Model: Model K- P3		Date: 2-Oct-03	No.: MG091001
Modified Article: Parts catalog correction		Prepared by: T.Shintani	
From: 1st Technical Support Sec. Service Support Dept.			
Reason for Modification:	<input checked="" type="checkbox"/> Parts catalog correction <input type="checkbox"/> To facilitate assembly <input type="checkbox"/> Part standardization	<input type="checkbox"/> Vendor change <input type="checkbox"/> To improve reliability <input type="checkbox"/> Other	<input type="checkbox"/> To meet standards ()
Modification Schedule:	From first mass production.

Model: Model K- P3		Date: 17-Nov-03	No.: MG091002
Modified Article: Parts catalog correction		Prepared by: T. Shintani	
From: 1st Technical Support Sec. Service Support Dept.			
Reason for Modification:	<input checked="" type="checkbox"/> Parts catalog correction <input type="checkbox"/> To facilitate assembly <input type="checkbox"/> Part standardization	<input type="checkbox"/> Vendor change <input type="checkbox"/> To improve reliability <input type="checkbox"/> Other	<input type="checkbox"/> To meet standards ()
Modification Schedule:	From first mass production.

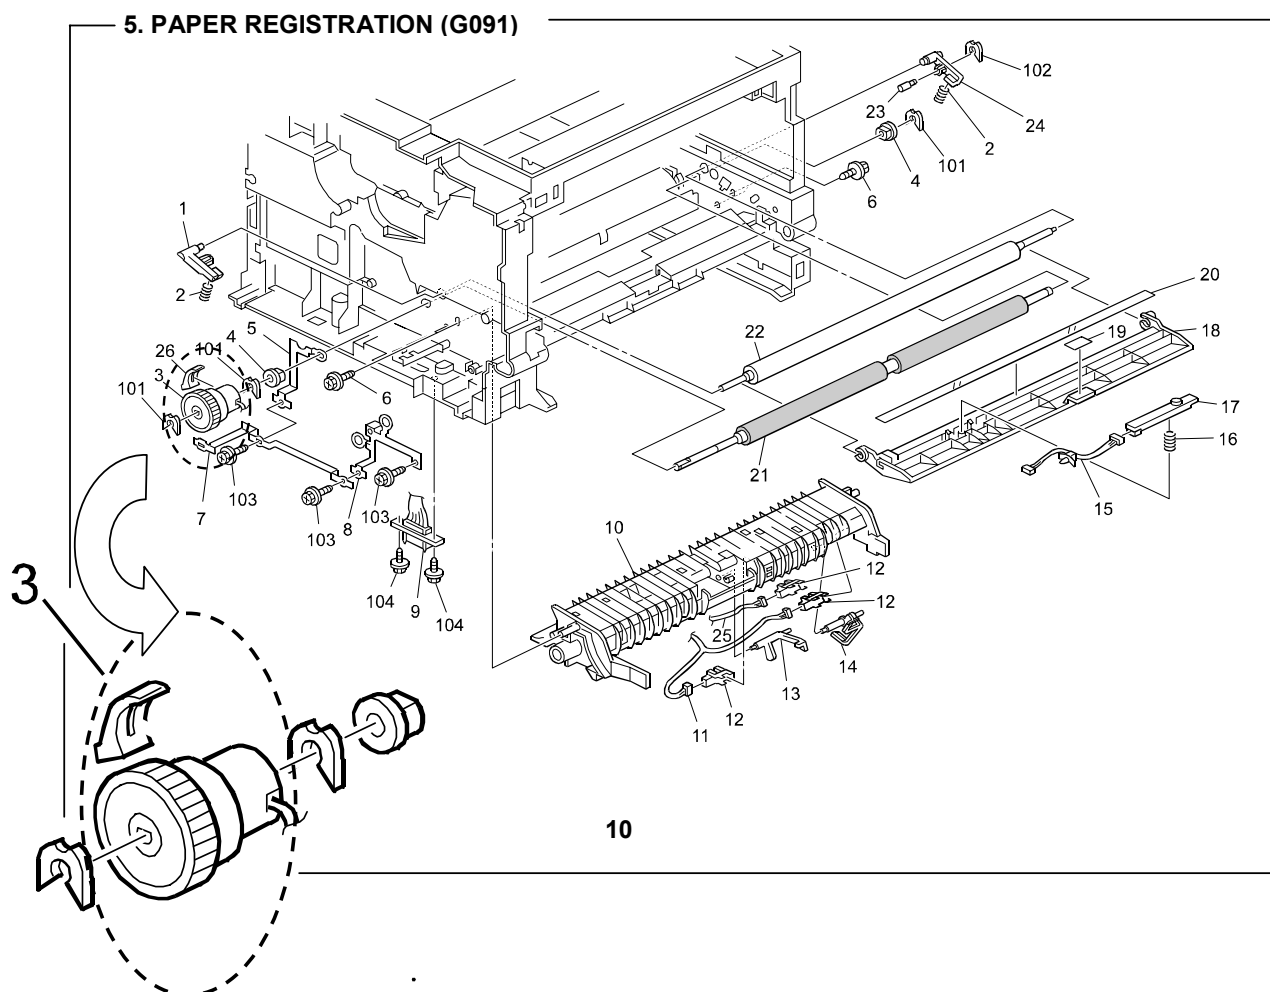
Old Part Number	New Part Number	Description	Q'ty	Int	Page	Index	Note
G0918617	G0918625	Operating Instructions – AP600N	1→1	- / -	37	9	1
G0881940B	G0881930F	Operation Panel NA Ass'y	1→1	- / -	3	10	2
G0884643	G0524644	Upper Fusing Entrance guide (EU)	1→1	- / -	15	22	3
G0563270	G0763270	Manual Feed Table : Ass'y	1→1	- / -	3	18	4
G0563271		Bypass Front Cover –RIC Europe/Asia	1→0	- / -	3	19	4
	G0523272	Bypass Front Cover	0→1	- / -	3	19	4

1. The O/I have been standardized with those for the General model (G091-11/G091-17).
2. The operation panel assembly for the EU model has been standardized with the assembly for the NA model (display changed from symbols to English).
3. (P/N misprint).
4. The bypass front cover has been standardized to the cover for the NA model ("Aficio" logo deleted).

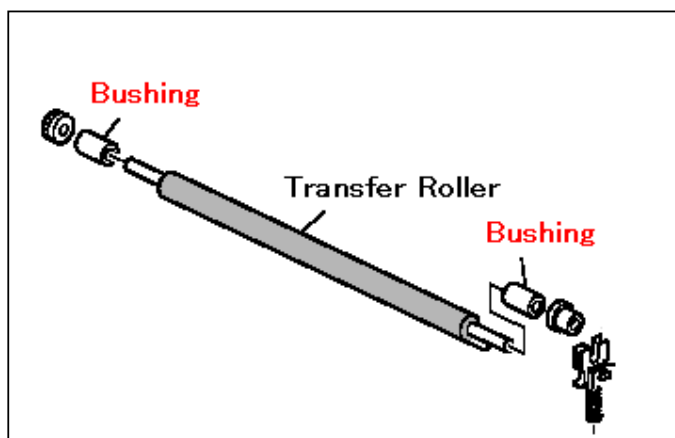
Old Part Number	New Part Number	Description	Q'ty	Int	Page	Index	Note
G0523616	G1116256	Transfer Roller	1→1	See Note	13	5	
G0523618	G1296251	Positioning Roller - Transfer	1→1		13	6	
G0763619	G1296252	Gear – Transfer Roller	1→1		13	4	
	G1296255	Bushing	0→2		13	28

Change/Reason: Parts standardization with the next model (Model K-P4).

Important: *All of the new parts in the table must be installed together as a set. You cannot install the new parts individually.*

5.PAPER REGISTRATION (G091/G116)

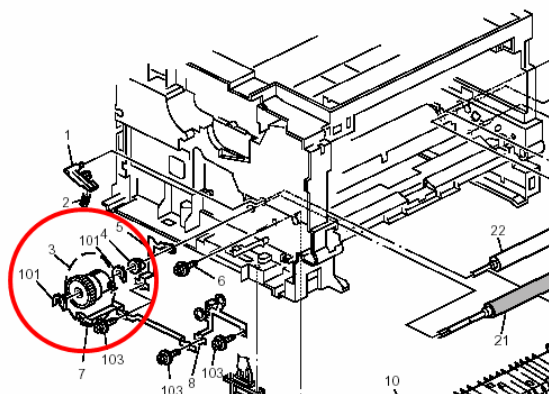
Old Part Number	New Part Number	Description	Q'ty	Int	Page	Index	Note
G0763205	G1292585	Magnetic Clutch Ass'y – Regist (G091 G116)	1→1		11	3	
AX200209		Magnetic Clutch-Z25(G091)	1→0		21	2	
G1202582	GX200026	Magnetic clutch registration :0.35N·M:Z45 (G091 G116)	1→1		21	2	
G1112590	GX200027	Magnetic clutch – internal :0.25N·M:Z25 (G091 G116)	1→1		21	2

- 1) P/N AX200209 was deleted from the Parts Catalog
- 2) The type of grease applied to the clutches on the production line was changed.

- 1) P/N AX200209 and its description were incorrect.
- 2) To improve the reliability of these clutches.

Note: P/N G1292585 (pg. 11, index #3) includes P/N GX200026.

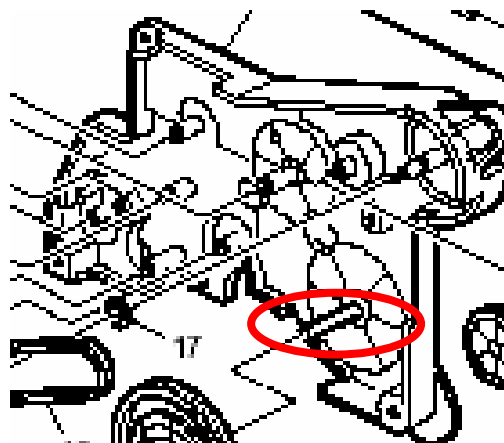
Old Part Number	New Part Number	Description	Q'ty	Int	Page	Index	Note
G0521102	M0011122	Drive Unit Bracket	1→1		21	20

Change: The material of the shaft was changed.

Reason: To further improve the performance of the drum drive mechanism.
